IN THE DRAWINGS

REMARKS

Amendments to the Drawings

FIG. 2

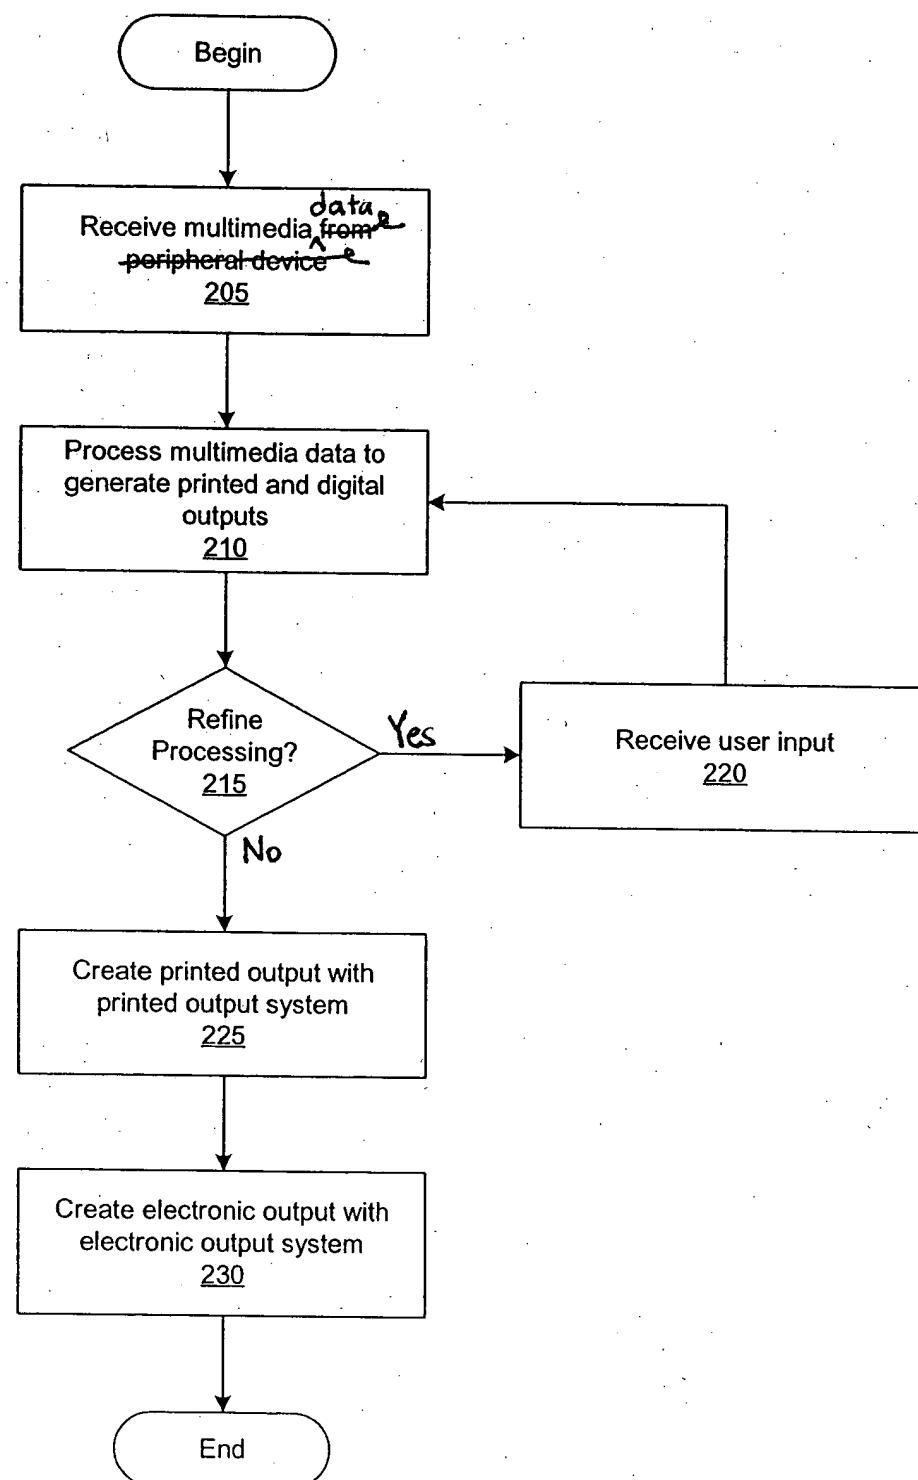
Applicants have amended Fig. 2 to state "Receive multimedia data 205." This amendment is supported by the specification in paragraph [0026]. Applicants have amended Fig. 4 to explicitly include a dashed outline and a reference numeral 115 to identify printed output system 115. This amendment is supported by Fig. 1 and paragraphs [0043]-[0046] of the specification. Applicants have amended Fig. 5 to explicitly include a dashed outline and a reference numeral 120 to identify electronic output system 120. This amendment is supported by Fig. 1 and paragraphs [0047]-[0054] of the specification. Applicants have amended Fig. 8 to attach all lead lines to the proper boxes or

Fig. 8

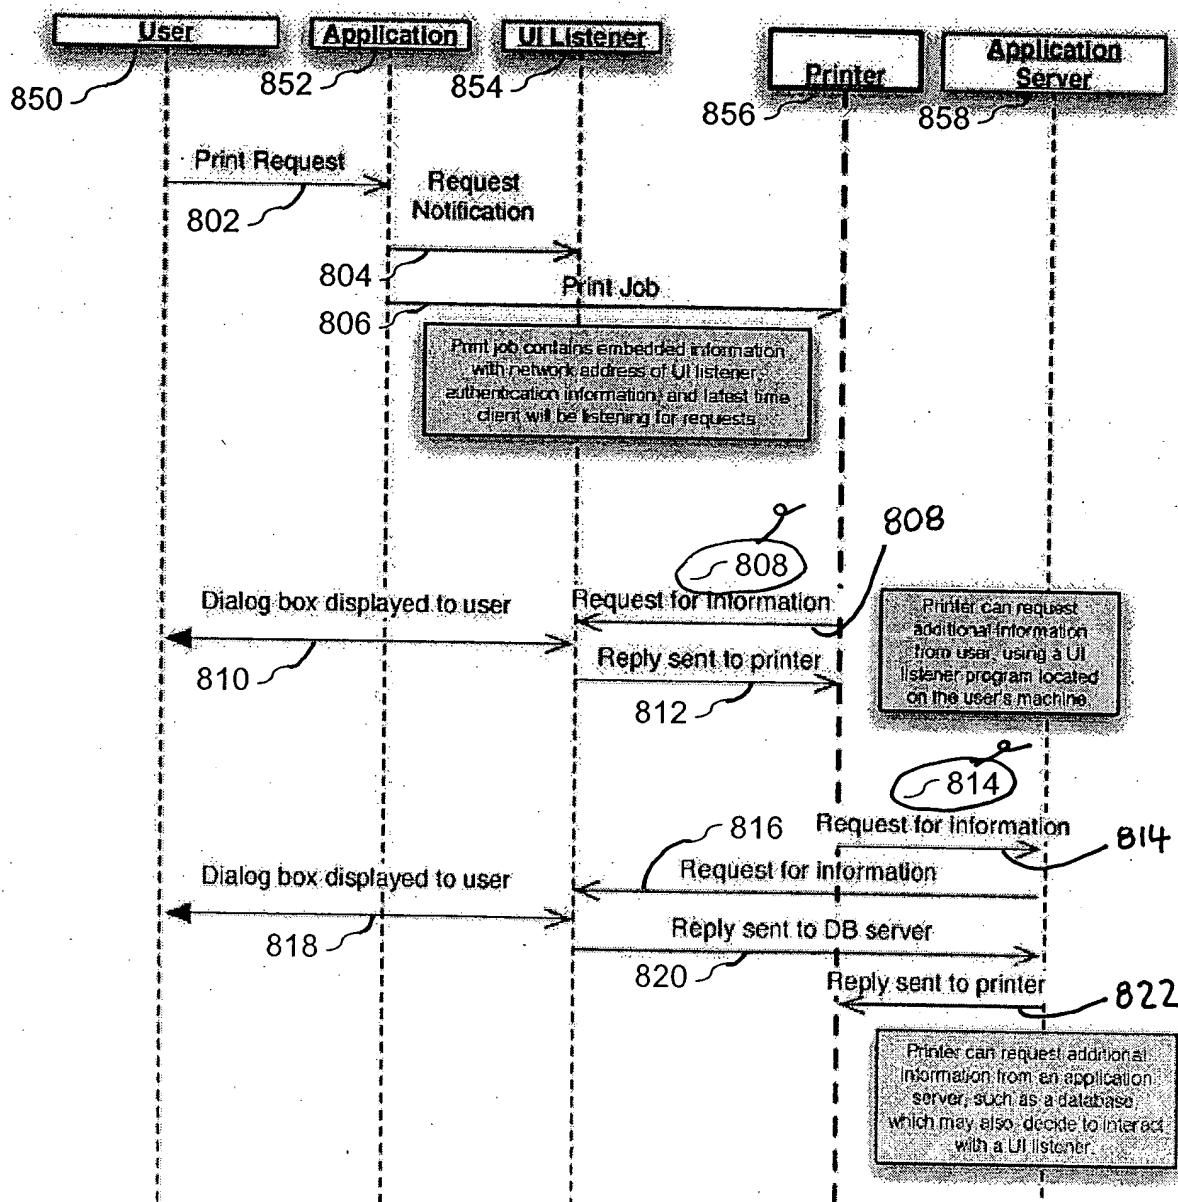
Paragraph [0064] was additionally amended to relocate reference numeral 804 for clarity, to correct typographical errors in identifying UI listener 854, and to include reference numeral 806, which was originally present in Fig. 8. Lastly, various amendments were made to paragraph [0065] to correct typographical and/or grammatical errors, to identify the printer with reference numeral 856, to identify the UI listener with reference numeral 854, to relocate reference numeral 810 for clarity, to correct typographical errors in identifying user 850, to correct typographical errors in identifying application server 858, to include reference numeral 820, which was included in original Fig. 8, and to include reference numeral 822, which was added to Fig. 8 by amendment.

arrows, to relocate reference numerals 808 and 814 to facilitate attaching their respective lead lines to the proper arrows, and to include reference numeral 822 to identify a reply sent from the application server 858 to the printer 856. The addition of reference numeral 822 is supported by paragraph [0065] of the specification.
